Manuscript Number: FST10-216R1

Title: Application of PACTITER v3.3 to the ACPs assessment of ITER Neutral Beam Injectors Primary Heat Transfer System

Answers to the reviewers' comments

Fig. 3. 3HNB + 1DNB Process Flow Diagram (PFD)

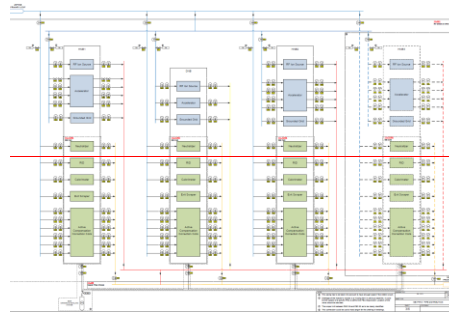
Q4. Figures: Increase the font size in Figures 2 and 4. Figure 3 will be impossible to read anyway (remove!). Figures 5, 6, 7 and 8 are not compatible with B&W publication.

A4: Figure 2 and 3 eliminated, Fig. 4 (now Fig. 2) and related characters enlarged, Figs. 5, 6, 7 and 8 (now Figs. 3-6) made in B&W and related characters increased.

Fig. 4. NBI-PHTS geometric model for PACTITERv3.3

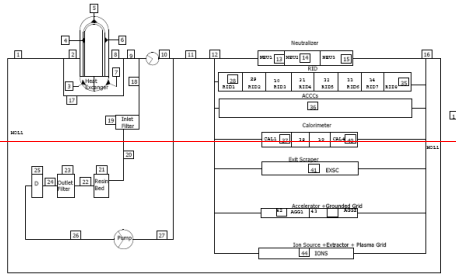
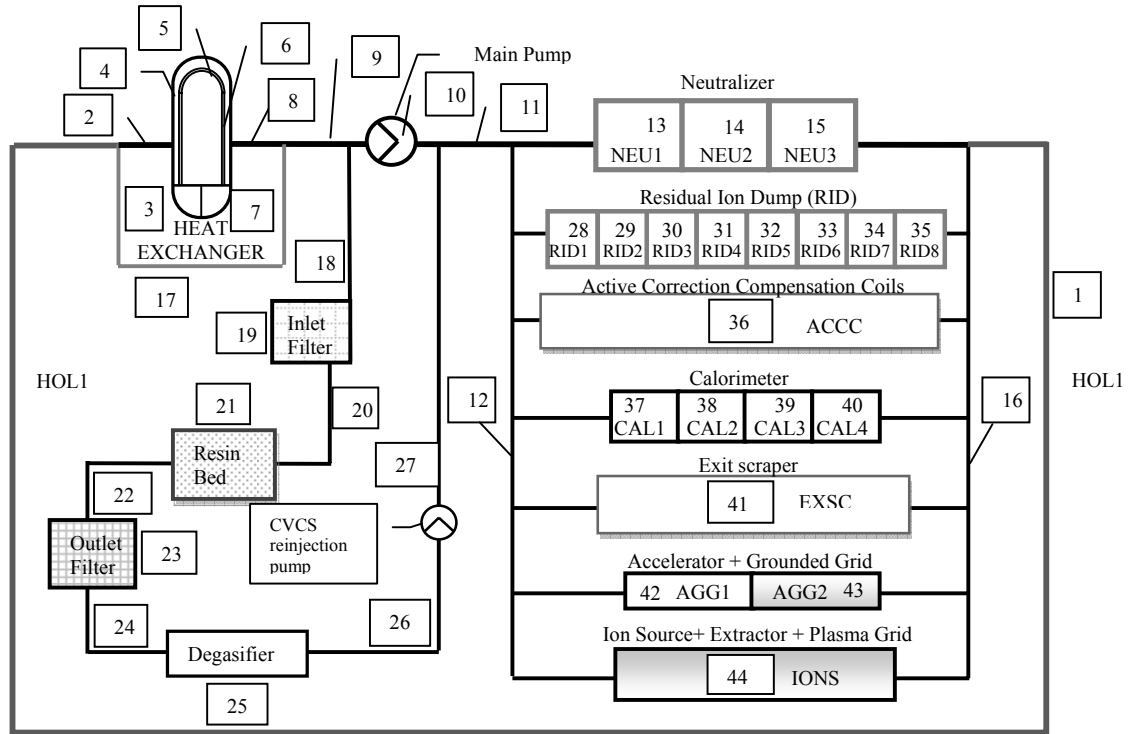
*Figs. 2-5 are too small to read. **[Fig. 2 & 3 crossed out, Fig. 4 enlarged (now Fig. 2), characters of Fig. 5 enlarged (now Fig. 3)]**

Fig. 53. PACTITER ACP mass for the different runs

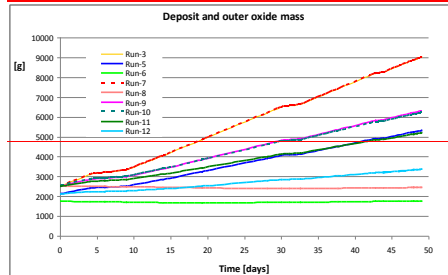
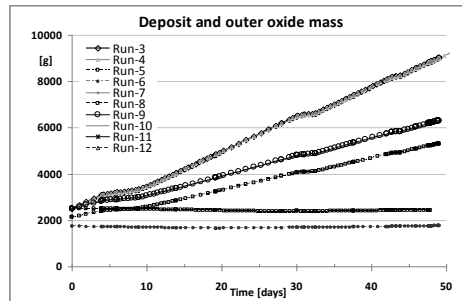
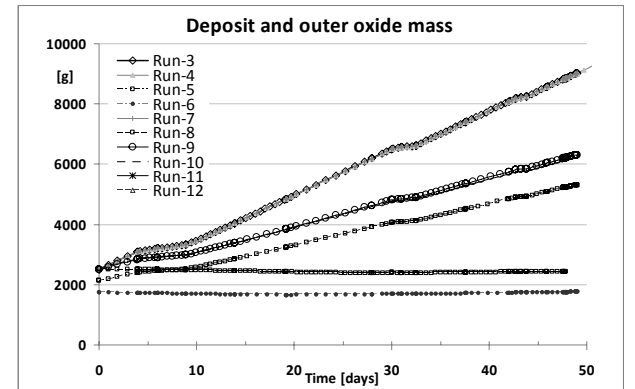
*Figs. 5-7 need the fonts increased. **[DONE, now Figs. 3-5]**

*Figs 5-8 may lose info in b&w. **[DONE, now Figs. 3-5]**

Fig. 8. ACP under flux activity in NBI-PHTS with ACCCs (Run-3) and without ACCCs (Run-8)

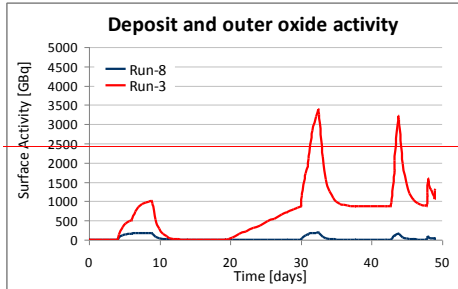
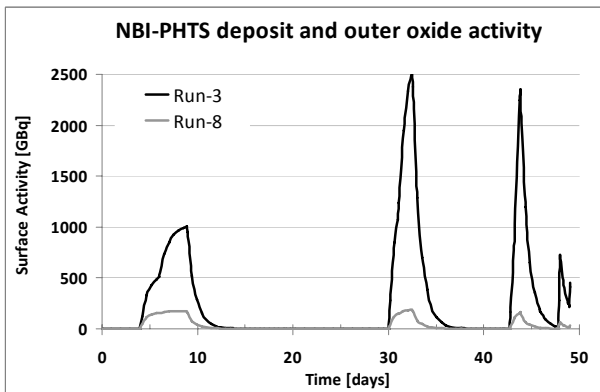
*Fig. 8 data lines could be differentiated by something else rather than color. **[DONE, now Fig. 6]**
